7695: Reading International Logistics Park, Reading, Berkshire

Briefing Note: Lighting Strategy Review

- Appendix 1: Proposed External Lighting Layout NMA by Engineering Services Consultancy Limited (Drawing Number: 2092-ESC-00-ZZ-DR-E-2102, Revision: P3)

Proposed External Lighting Layout NMA by
Engineering Services Consultancy Limited
(Drawing Number: 2092-ESC-00-ZZ-DR-E-2101,
Revision: P3)

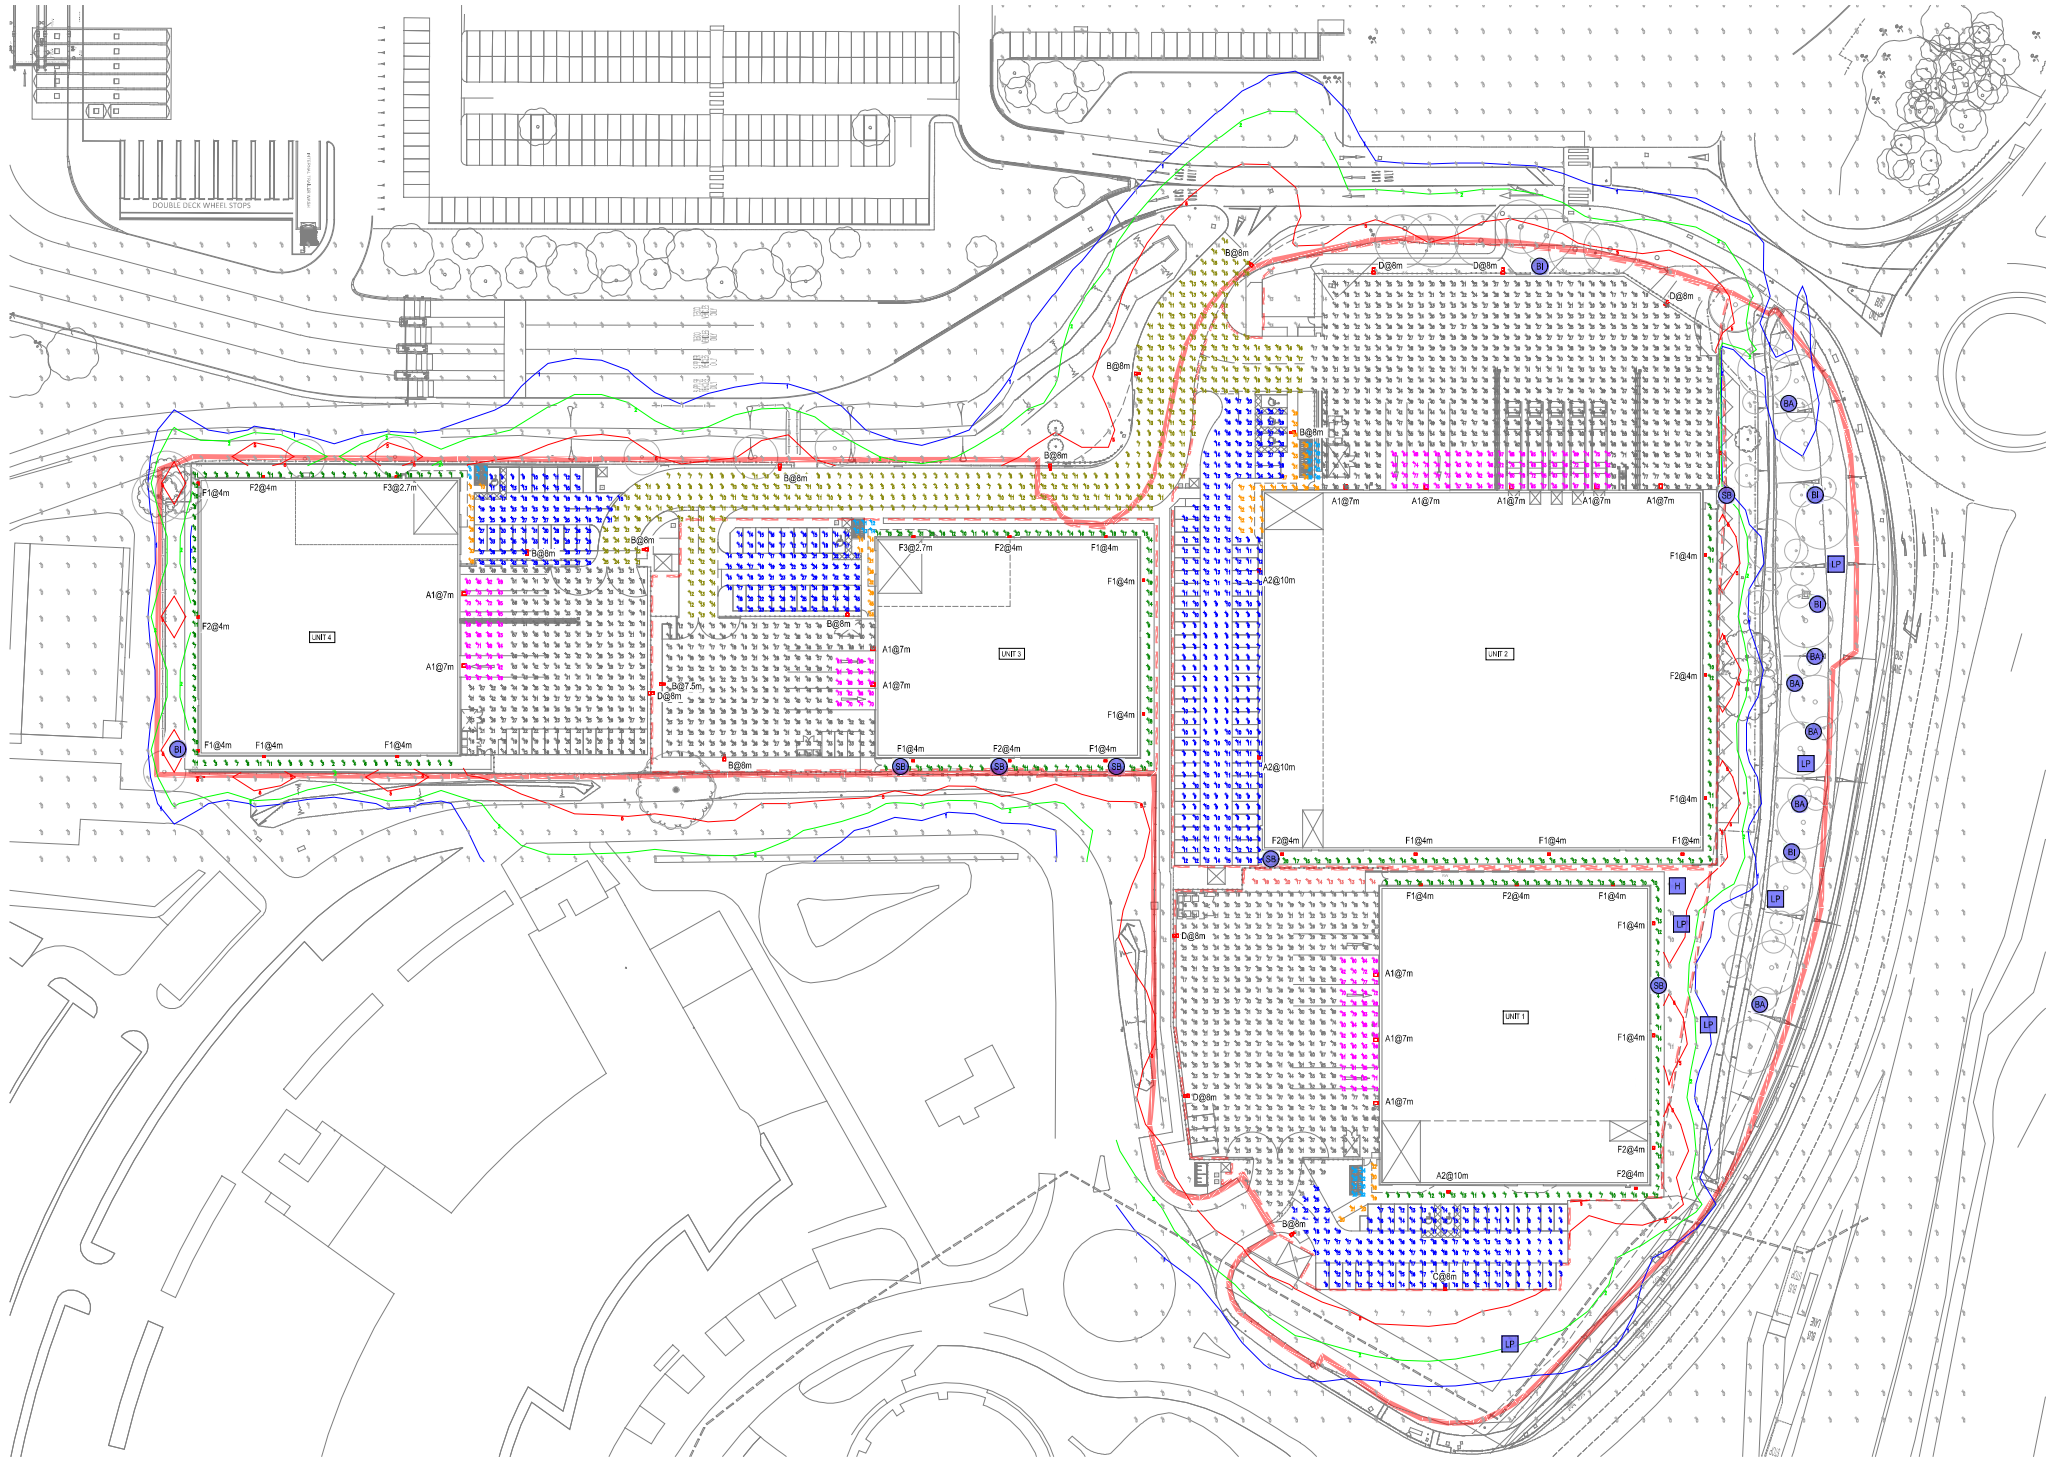
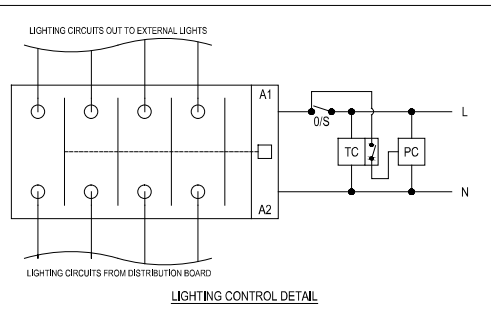
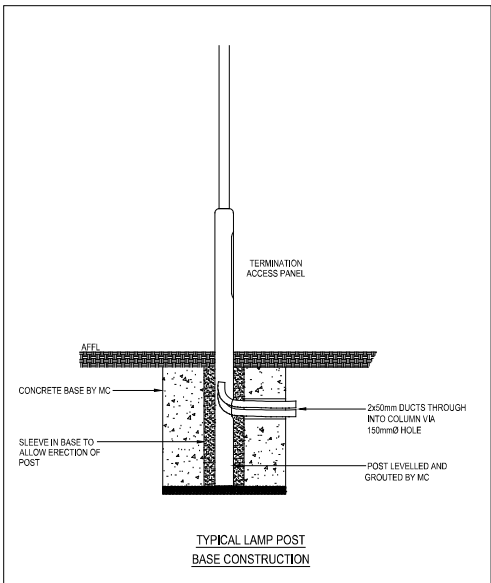
- 3.1. The isolux information indicates that the artificial lighting is predominantly concentrated towards the operational areas of the site, away from the retained vegetation of ecological importance and proposed ecological enhancement measures.

- 3.2. Light Emitting Diodes (LEDs) will be exclusively used, giving a more directional beam of light than more traditional lighting options. These are understood to be warm white LEDs, favoured by bats, albeit have a slightly higher colour temperature than outlined within the guidance (i.e. they have a colour temperature of at least 3000°K, whereas 2700K is recommended within the guidance).

- 3.3. It is also understood that, where the lighting columns are required in closer proximity to the perimeter of the site, they will be fitted with back-shields, limiting slight spill on boundary / off-site habitats of greater suitability for wildlife as far as possible.

- 3.4. Through these measures, the majority of the northern retained tree / wooded belt is not subject to any increased artificial light spill as a result of the development (i.e. is shown as zero lux on the revised Proposed External Lighting Layout NMA), with the small north-western section that does have increased light spill only subject to an increase of one to two lux. As such, it is expected that this area of retained habitat will continue to offer largely unimpeded suitability for nocturnal species, including foraging and commuting bats.

- 3.5. Additionally, given that all the proposed bat boxes are to be incorporated into the northern retained tree / wooded belt, the lighting strategy would not adversely impact the post-development suitability of the site for roosting bats.

- 3.6. Although it is acknowledged that some low-level illumination (generally between one and three lux, albeit occasionally slightly higher) extends onto and beyond parts of the eastern and western site boundaries and their associated on- and off-site retained habitats, given the wider context of the site, and especially the known existing light spill on these boundary habitats from the surrounding commercial development (i.e. the access road for the Tesco distribution centre adjacent to the west of site and the access road associated with the existing business park beyond the eastern site boundary), it is considered unlikely that the ecological functionality of the retained habitats for foraging and commuting bats would be materially impacted as a result of the development proposals.

- 4.2. This note considers the revised lighting proposals against current best practice guidance, specifically Bats and Artificial Lighting at Night (GN08/23), produced jointly by the BCT and ILP.
- 4.3. It is considered that the design of the lighting strategy successfully avoids, or sufficiently limits, artificial light spill on retained vegetation of ecological interest, as well as the proposed ecological enhancement features (i.e. bat boxes). As such, it is considered that the integrity of the site for nocturnal species, and specifically foraging and commuting bats, is maintained and the development is in accordance with relevant guidance.
